Application for Licence Amendment

Licence Number	L8912/2015/1
Licence Holder	Halls Creek Mining Pty Ltd
ACN	168 093 347
File Number	DER2015/001934-1
Premises	Lamboo Gold Project M80/343, M80/355, M80/359, M80/362, M80/503, M80/471, L80/70, L80/71, L80/94 and L80/97 MUELLER RANGES WA 6770
Date of Report	10 August 2021
Proposed Decision	Revised licence granted

Figure 3 Current groundwater monitoring bores for TSF1 and TSF2 (GW1- GW9)

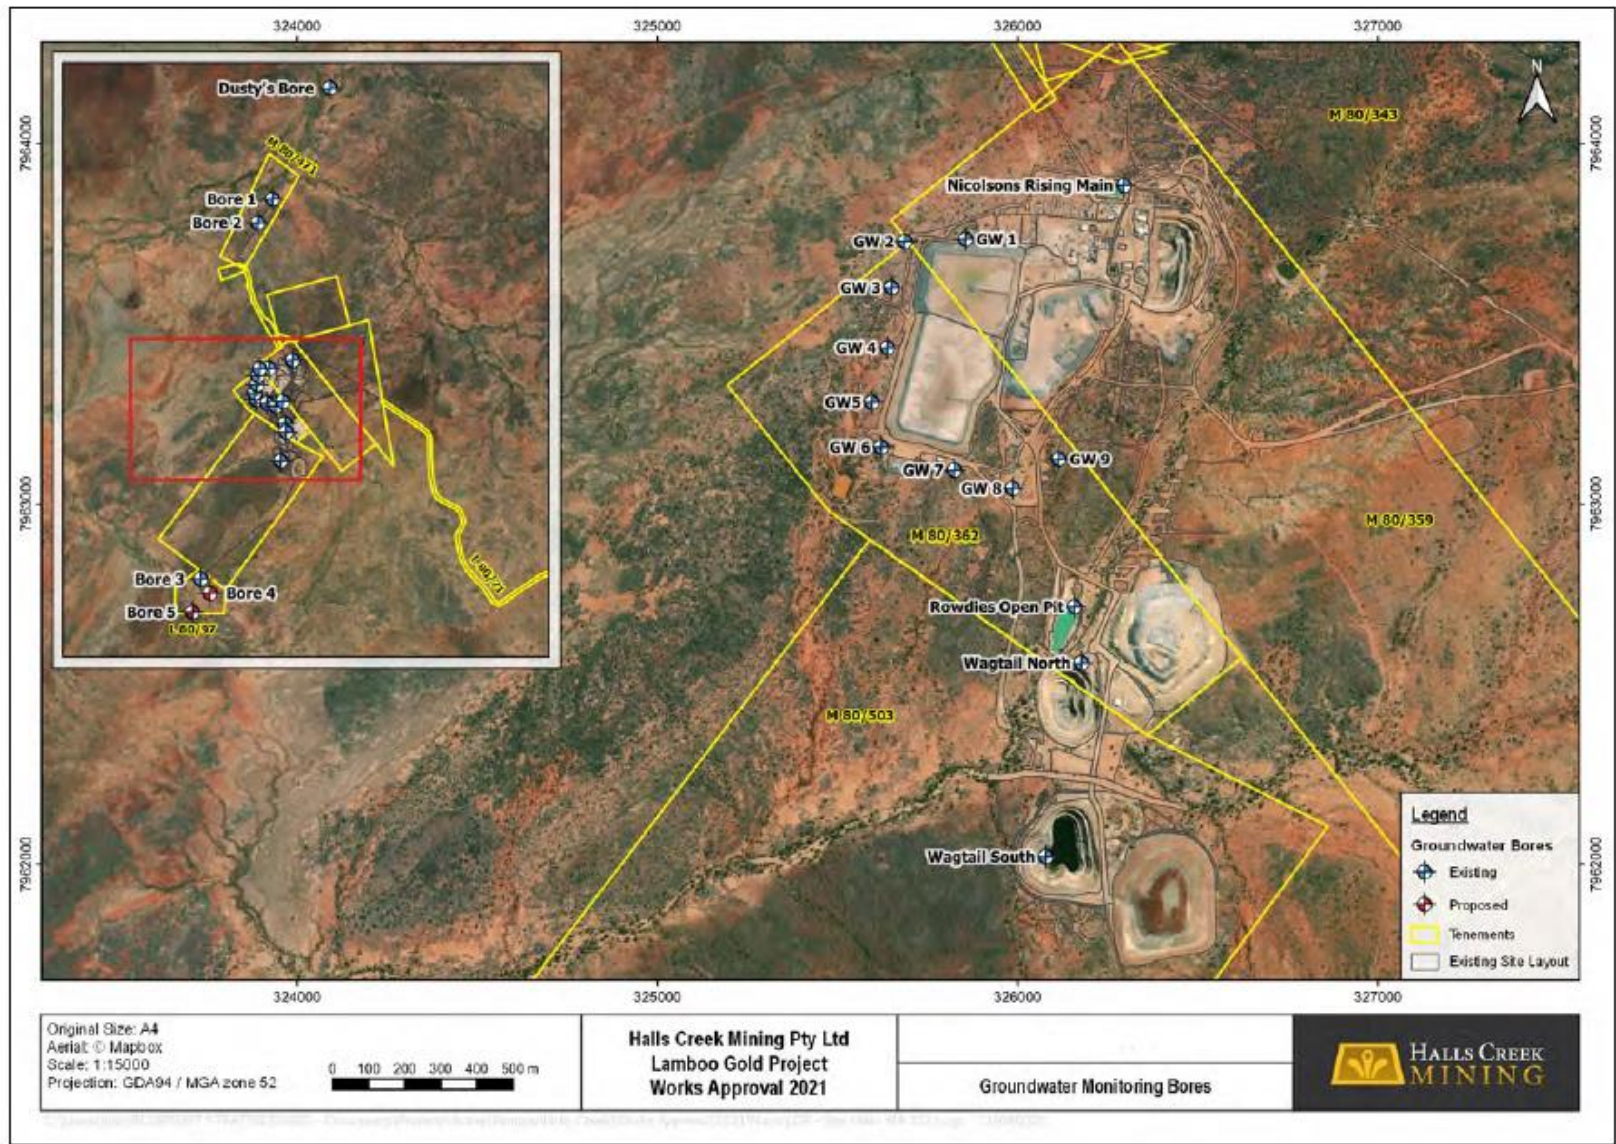
The current licence requires quarterly groundwater monitoring in 9 bores to capture potential seepage impacts from TSF1 and TSF2 (Figure 3). However, the groundwater bores are slotted at depth about 18 – 24 metres below ground level (mbgl), and have been dry since their installation, and therefore no groundwater monitoring has been undertaken at the facilities. It is understood that the depth to groundwater is at approximately 40 – 45 mbgl. With the proposed embankment raises from RL:408 m to RL 411 m and additional tailings deposited, the adequacy of the groundwater monitoring to capture potential seepage has been considered.

A review by DWER's internal technical experts of the geological setting at the premises and the relevance of groundwater occurrence has been undertaken. It was advised that the bedrock lithologies and overlying weathered profile at the premises generally have a low permeability, so occurrence of groundwater is generally limited in the region. However, due to the heavy monsoonal rainfall that seasonally takes place in the region, it is likely that ephemeral perched aquifers form in the weathered profile overlying bedrock. This ephemeral groundwater flow is likely to be a more significant pathway but would be much more difficult to monitor due to fluctuating flows and water levels.

While the deep groundwater flow from the site is unlikely to be a major pathway for the transport of chemical constituents, it is a pathway which requires monitoring. Additional information provided by the licence holder as part of the review of the draft licence conditions and amendment report, supports that deep monitoring bores (approximately 50 mbgl) may not be required for this amendment. Deep monitoring bores may be considered as part of the future TSF2 expansion works, as proposed by the licence holder (Appendix 1).

This is particularly the case given that the risk of seepage increases with the proposed embankment raise. The current groundwater monitoring has therefore been found inadequate for capturing potential seepage impacts from the TSF1 and TSF2.

Currently, no groundwater monitoring has been undertaken at the premises due to bores being installed approximately 20 m above the groundwater table, which results in dry bores.

To capture the seasonal flow of perched groundwater near the TSF1 and TSF2, shallow bores may be required. Internal technical experts advise to undertake downhole geophysical logging using a natural gamma probe inside the PVC casing of all the existing dry monitoring bores around the toes of the TSF (GW1 – GW9, as set out in Figure 3). This identifies potential sandy layers which can be a pathway of seepage via a seasonally perched aquifer during wet season, resulting in saline porewater extending beyond the edges of the TSF.

A Hydrogeology Report (Rockwater, 2015) provided by the licence holder, shows groundwater in the project area is freshwater, with low salinity and of domestic and stock quality. The report included groundwater measurements in two bores (Bore 1 and Bore 2) located north of the TSF (on mining tenement M80/471), as well as six near-pit holes not further identified. Bore 1 and 2 had a TDS of 590 mg/L and 600 mg/L, respectively. The TDS in near-pit holes ranged from 370 – 530 mg/L. Findings of the downhole geophysical investigations are required to be reported to the department, which will determine if shallow monitoring bores are required.

1.4.1	Requirement to undertake further investigation to identify sandy horizon in the weathered profile which may act as pathway for seepage from the TSF1 and TSF2 during wet season.
